# SAN FRANCISCO PLANNING DEPARTMENT

## DRAFT Planning Commission Motion NO. M-XXXXX

*Hearing Date:* August 24, 2017  
*Case No.:* **2014-001272ENV**  
*Project Title:* **Pier 70 Mixed-Use District Project**  
*Zoning:* M-2 (Heavy Industrial) and P (Public)  
40-X and 65-X Height and Bulk Districts  
*Block/Lot:* Assessor's Block 4052/Lot 001, Block 4111/Lot 004  
Block 4120/Lot 002, and Block 4110/Lots 001 and 008A  
*Project Sponsor:* David Beaupre/Port of San Francisco  
[david.beaupre@sport.com](mailto:david.beaupre@sport.com), (415) 274-0539  
Kelly Pretzer/Forest City Development California, Inc.  
[KellyPretzer@forestcity.net](mailto:KellyPretzer@forestcity.net), (415) 593-4227  
*Staff Contact:* Melinda Hue – (415) 575-9041  
[melinda.hue@sfgov.org](mailto:melinda.hue@sfgov.org)

### ADOPTING FINDINGS RELATED TO THE CERTIFICATION OF A FINAL ENVIRONMENTAL IMPACT REPORT FOR THE PROPOSED PIER 70 MIXED-USE DISTRICT PROJECT.

**(REVISED) FIGURE 2.15: PROPOSED OPEN SPACE PLAN**

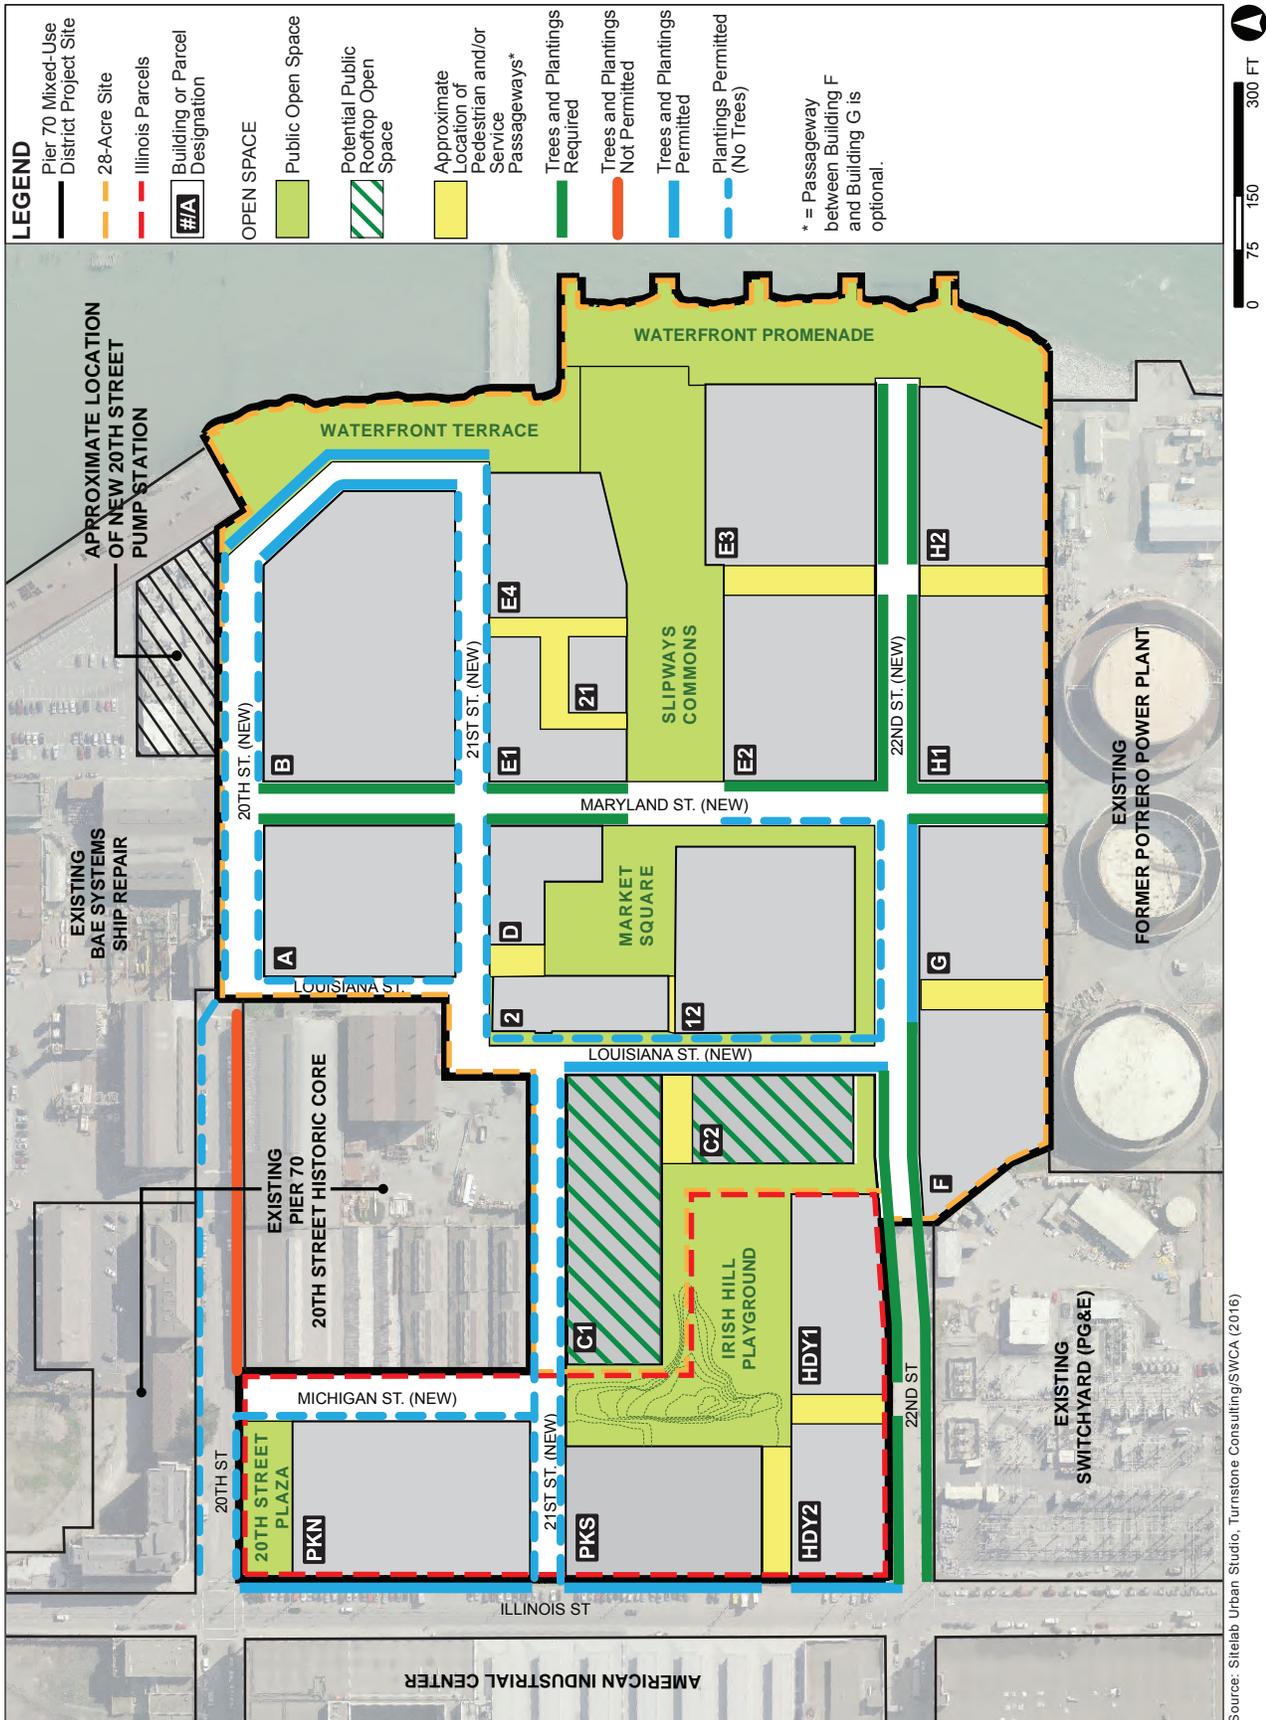
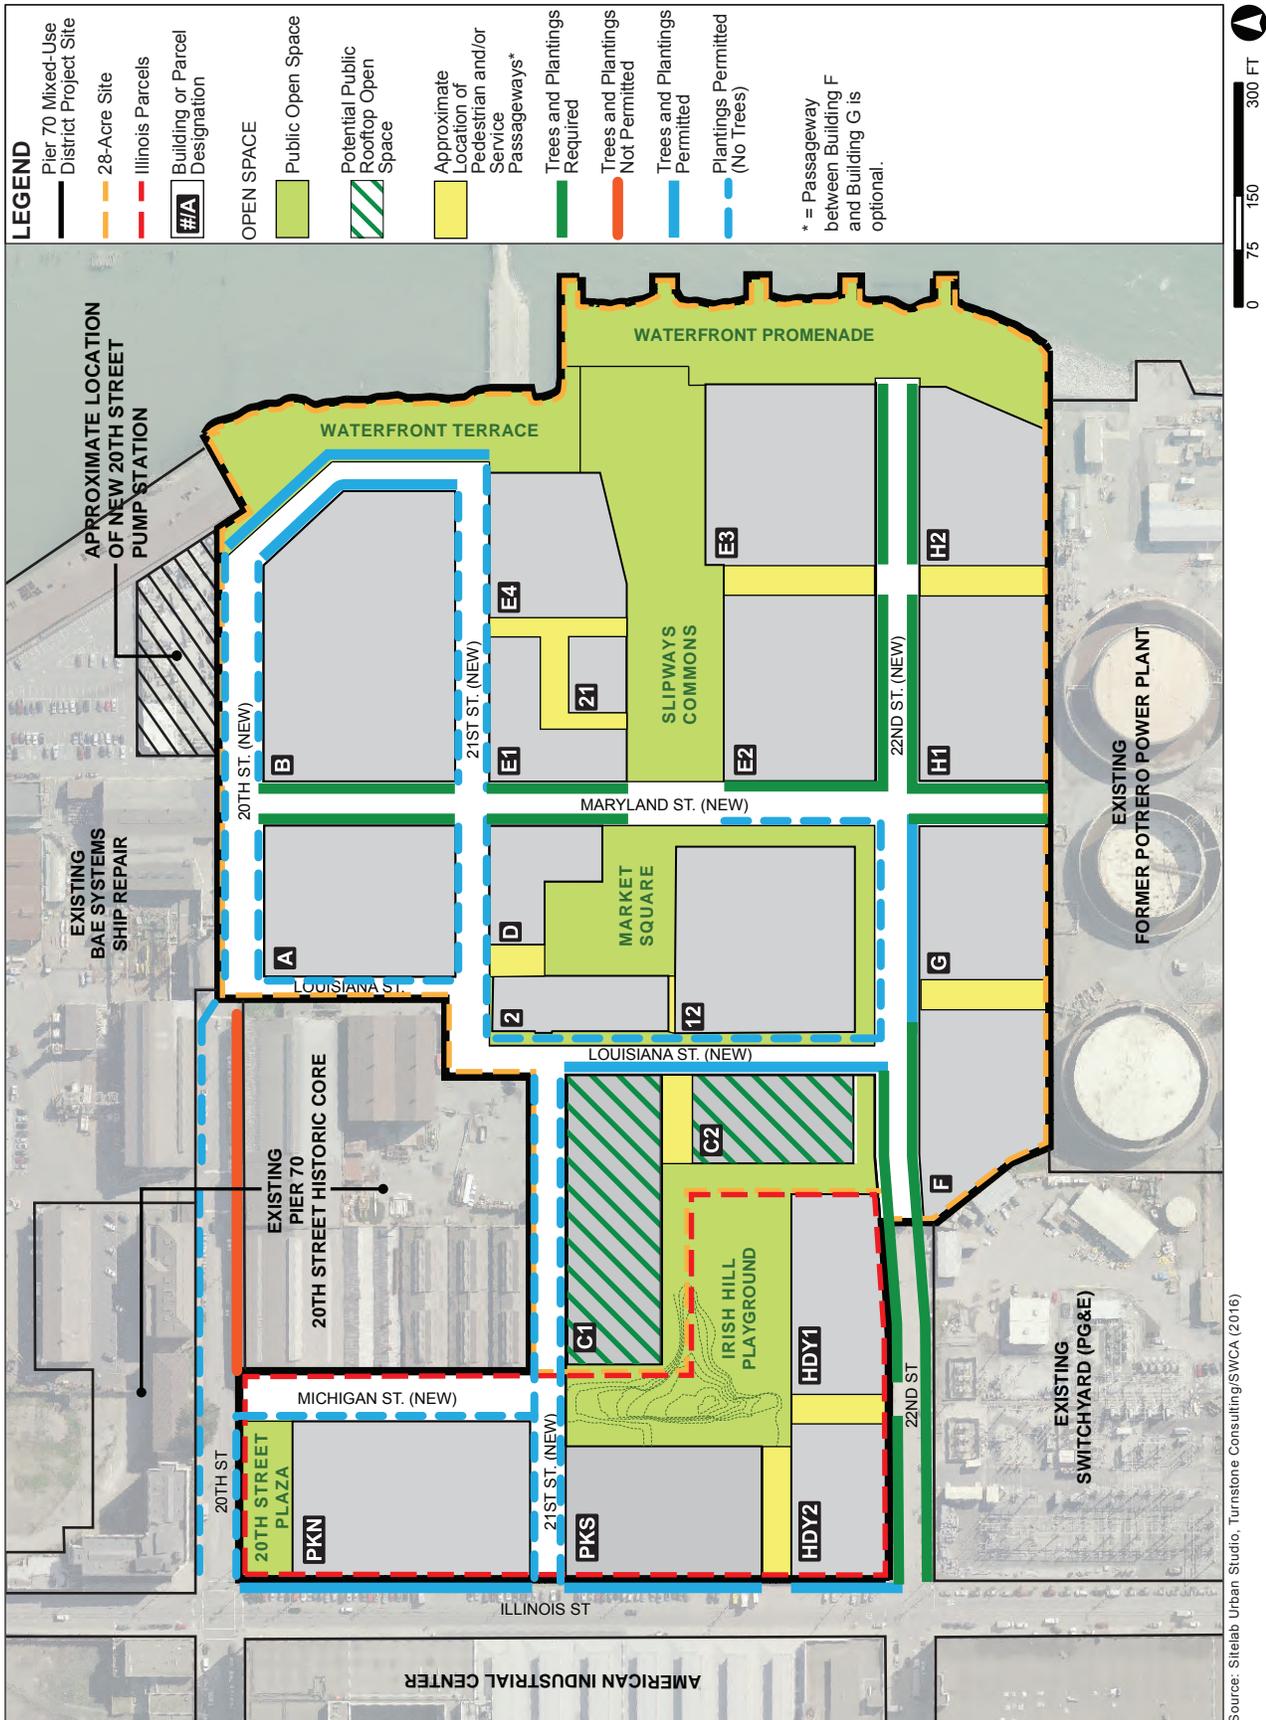
Figure 2.15: Proposed Open Space Plan, on EIR p. 2.46, has been revised to reflect the changes to street tree locations, as follows. The scale bar has also been revised as a staff-initiated text change, as discussed in Chapter 5, Draft EIR Revisions, p. 5.32, of this RTC.

- \* Figure 2.15: Proposed Open Space Plan, on EIR p. 2.46, has been revised to reflect the changes to street tree locations, and its scale bar has also been revised. The revised figure is shown on RTC p. 5.33.
- \* To update the text to further expand upon the Proposed Project open space plan, two new paragraphs have been added after the paragraph under the heading “Rooftop Open Space Areas” on EIR p. 2.48, as shown below (new text is underlined). These revisions do not change any of the analyses or conclusions of the EIR.

(REVISED) FIGURE 2.16: PROPOSED ROADWAY NETWORK

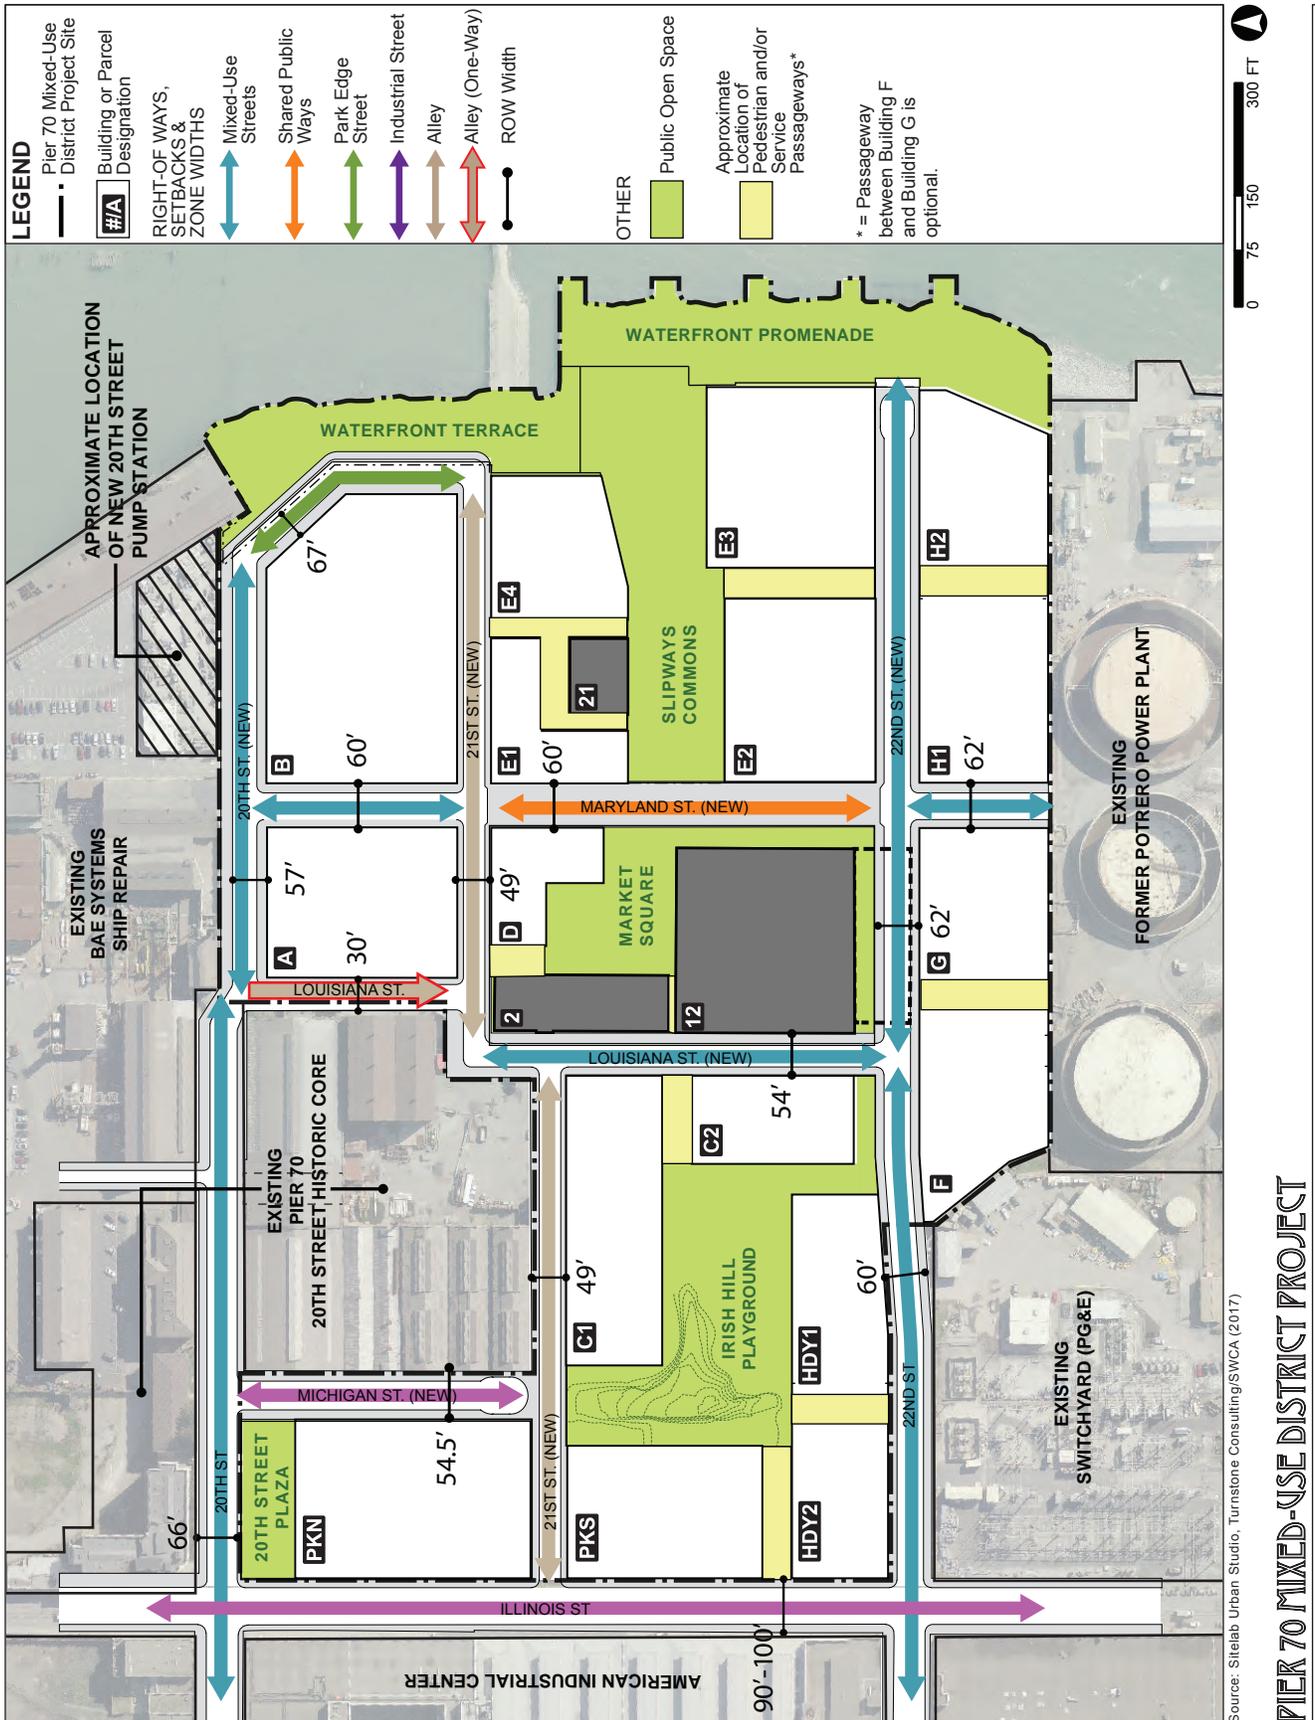
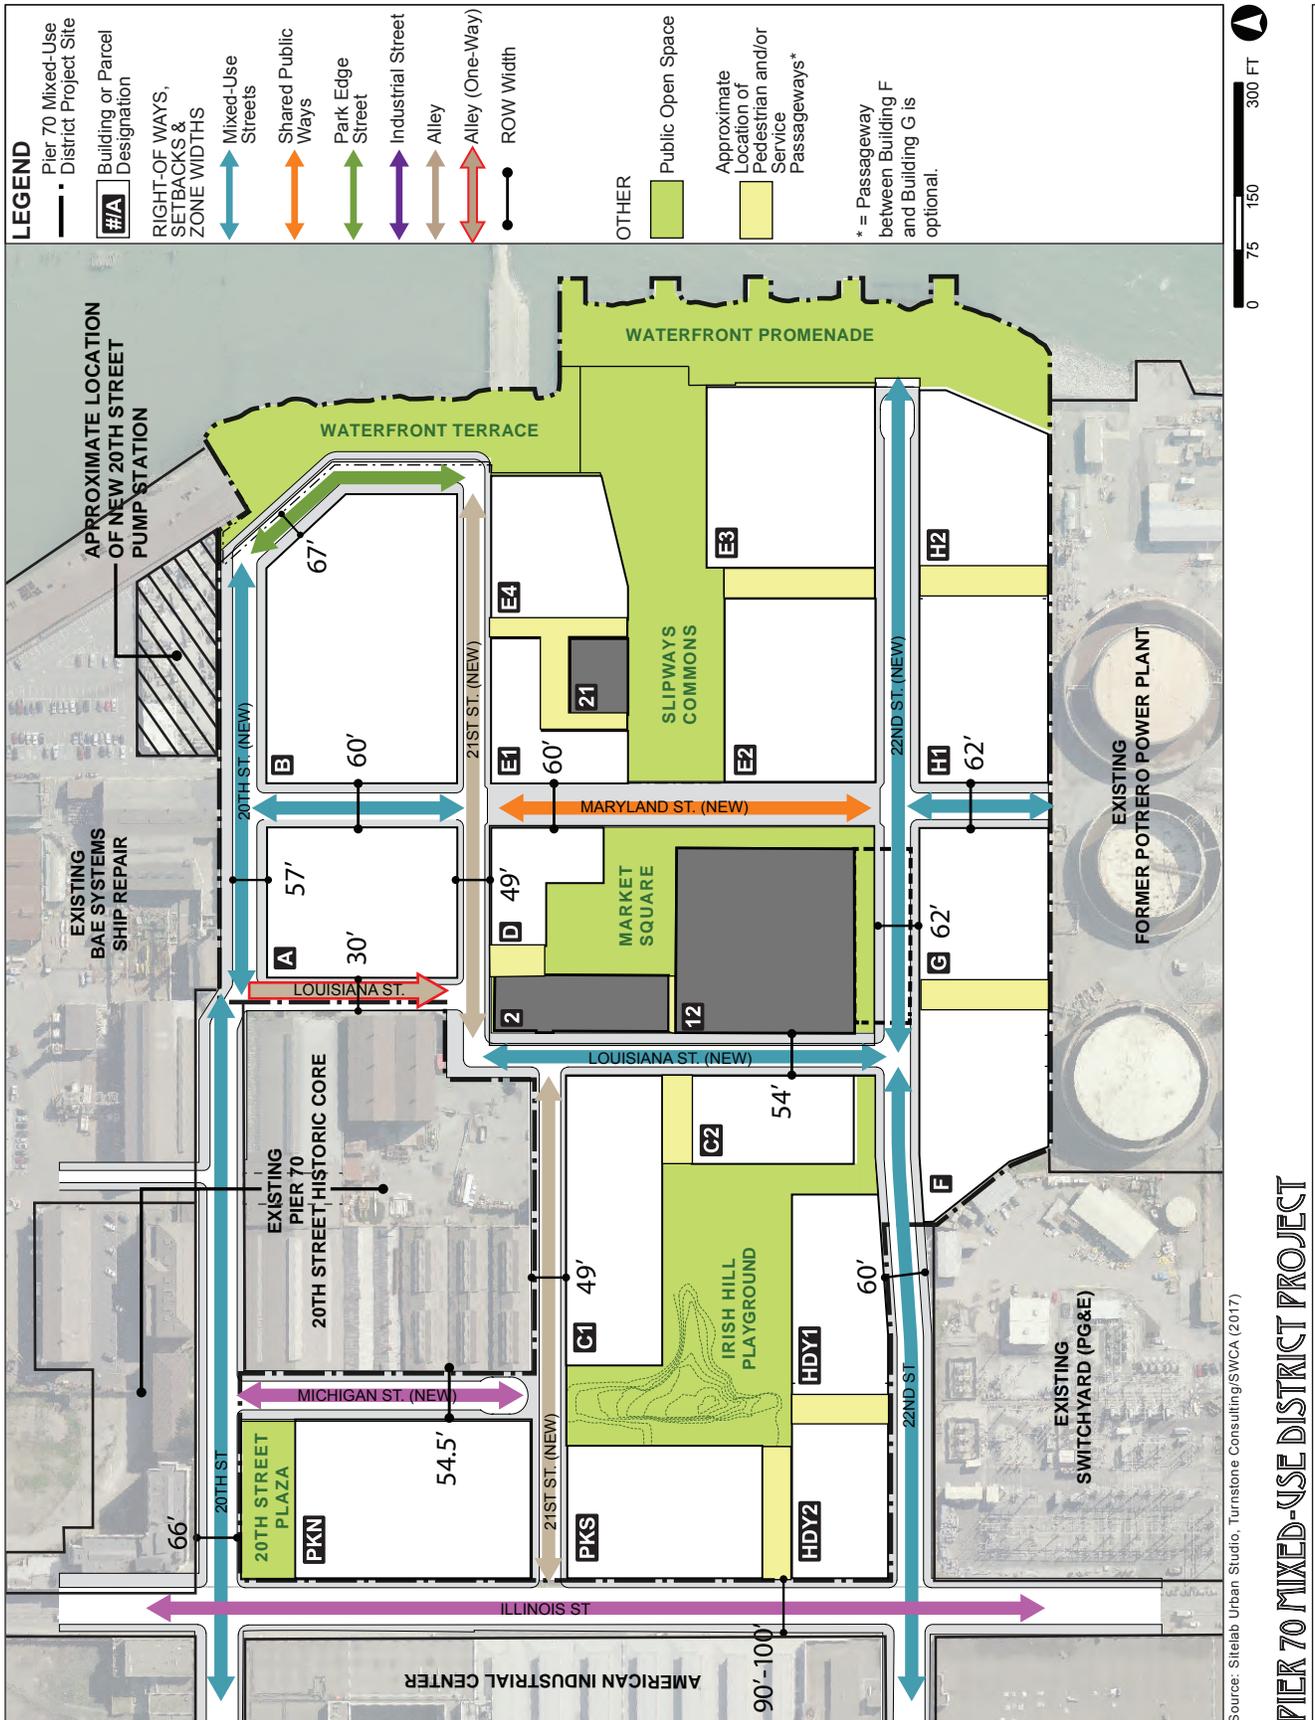
Figure 2.16: Proposed Roadway Network, on EIR p. 2.50, has been revised to reflect the right-of-ways, setbacks, and zone widths established in the *Design for Development*, as follows. The scale bar has also been revised as a staff-initiated text change, as discussed in Chapter 5, p. 5.32, of this RTC.

- \* Figure 2.16: Proposed Roadway Network, on EIR p. 2.50, has been revised to reflect the right-of-ways, setbacks, and zone widths established in the *Design for Development*, and its scale bar has also been revised. The revised figure is shown on RTC p. 5.34.
